**TOWN OF NEWBURGH
PLANNING BOARD
TECHNICAL REVIEW COMMENTS**

PROJECT: FIDANZA
PROJECT NO.: 11-24
PROJECT LOCATION: SECTION 80, BLOCK 7, LOT 7
REVIEW DATE: 31 MARCH 2016
MEETING DATE: 7 APRIL 2016
PROJECT REPRESENTATIVE: M.A. DAY ENGINEERING

**RE: PROPOSED RETAIL/OFFICE BUILDING
Lands of Franco Fianza
North Plank Plaza, LLC
Route 32 (North Plank Road), SBL 80-7-7
Town of Newburgh, Orange County
HWP # 2013 08 41172**

**Re: Project # 2011-24
North Plank Plaza, LLC
North Plank Road**

4 4' HIGH VINYL COATED CHAIN LINK FENCE
SCALE: N.T.S.

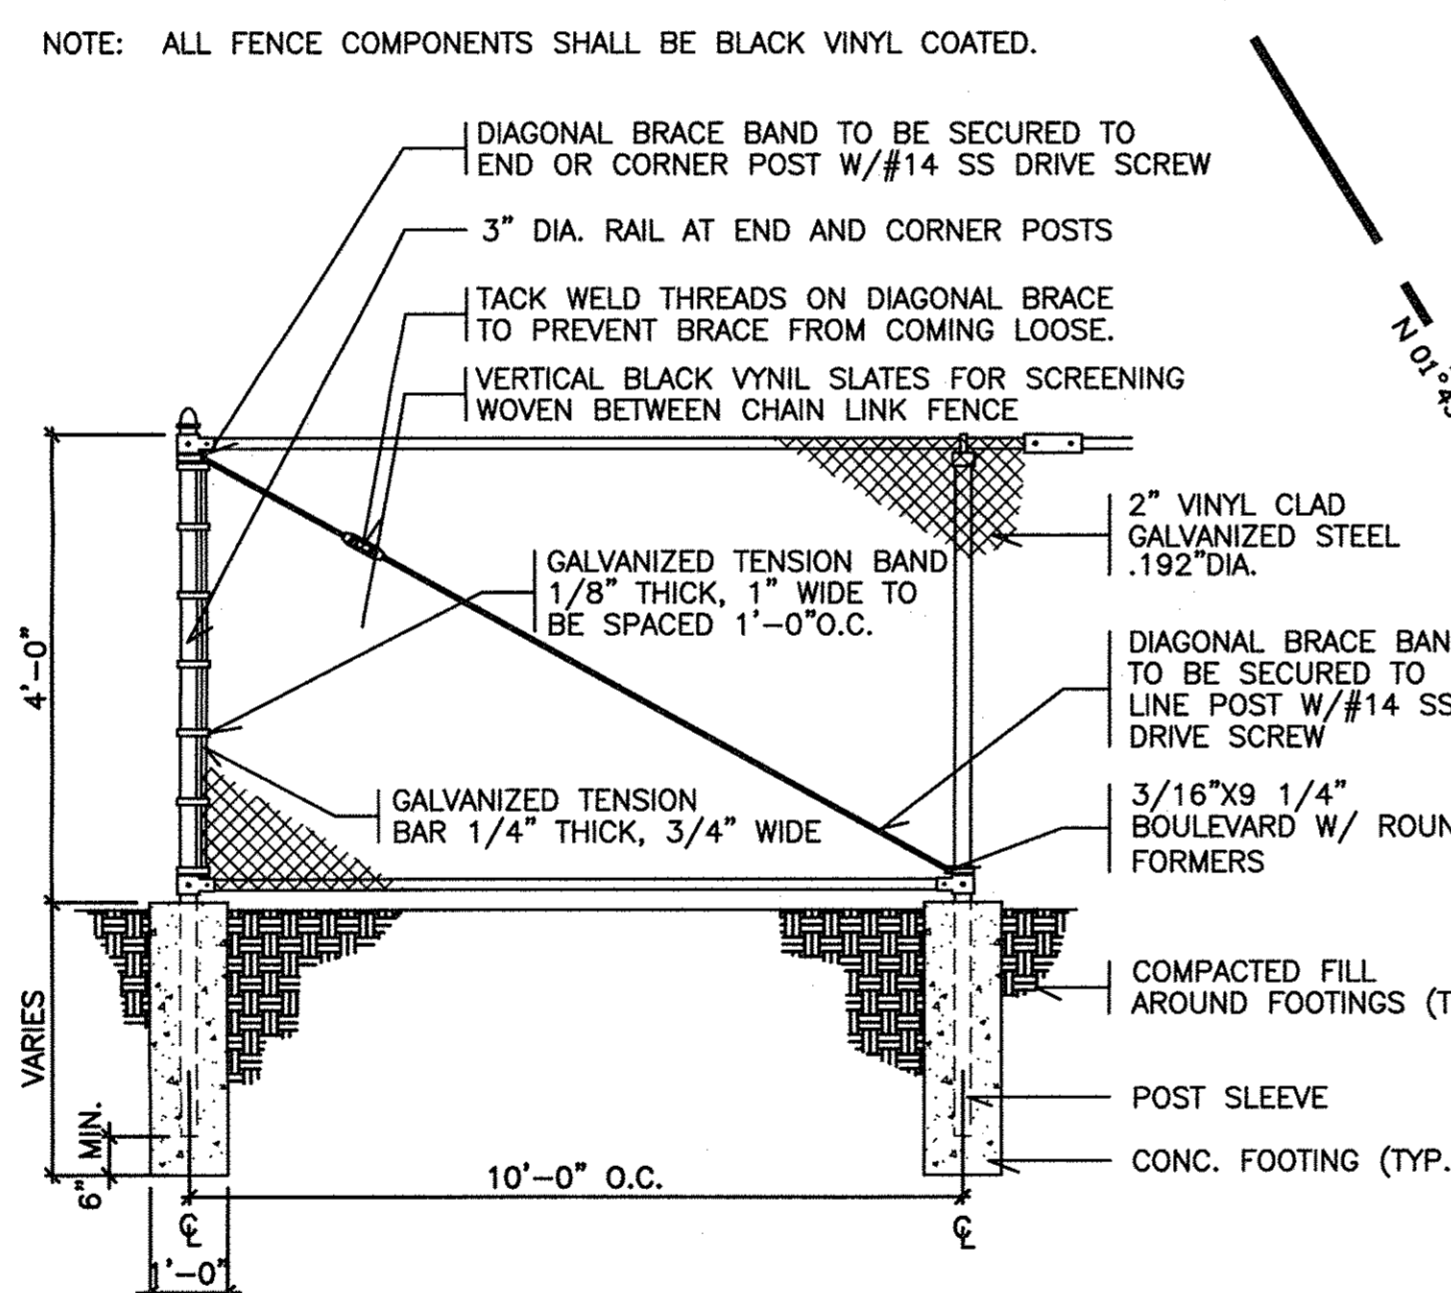
7. It is noted that the As Built plan does not depict the stone wall in the vicinity of the concrete walk. This should be clarified.
8. Fence details should identify how proposed fence will be installed on the modular block retaining wall that has been constructed. Fence detail does not address placement of the fence within the wall.
9. A revised Landscape plan has been provided for the Boards review.

SITE PLAN
1"=20'

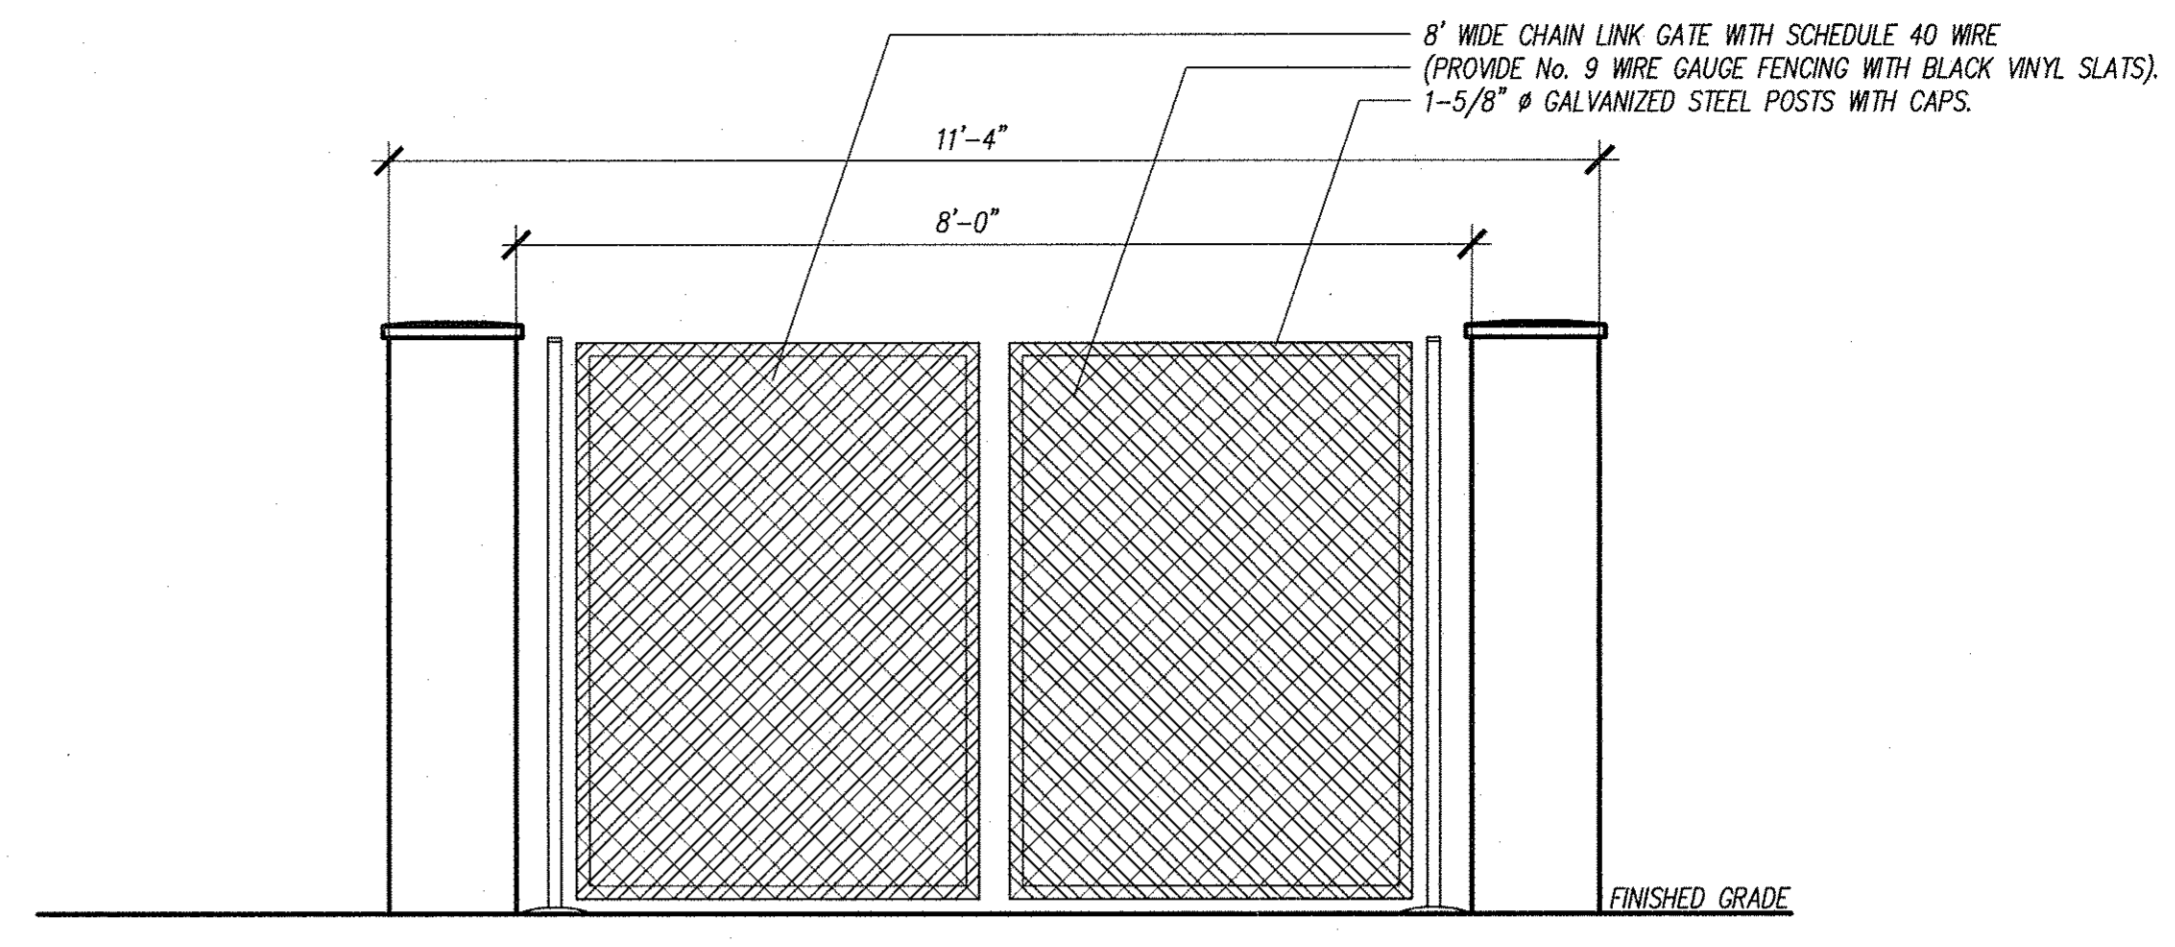
2. With the removal of the sidewalk it appears that the extension of the stone wall towards the State Highway will not be needed.
3. A proposed 4 foot high chain link fence is identified along the top of the retaining walls which have been constructed on the plans. Vehicle bumper blocks are proposed to protect the fence. We would recommend that guide rail be proposed on top of the wall in addition to the fence to protect vehicles from accidentally overtopping the wall. The As Built plan identifies the wall approximately 9 feet high.

5. The proposed fencing does not protect the entire wall area, based on the height of the wall we would recommend the fence and or vehicle barrier be constructed along the entire length of the wall.

6. Confirmation from the Applicant's Engineer that the Stormwater Management system has been constructed in compliance with the approved plans should be received. Several catch basins

have been depicted with rim elevations and no inverts. A certification as to the construction of the Stormwater system should be provided.
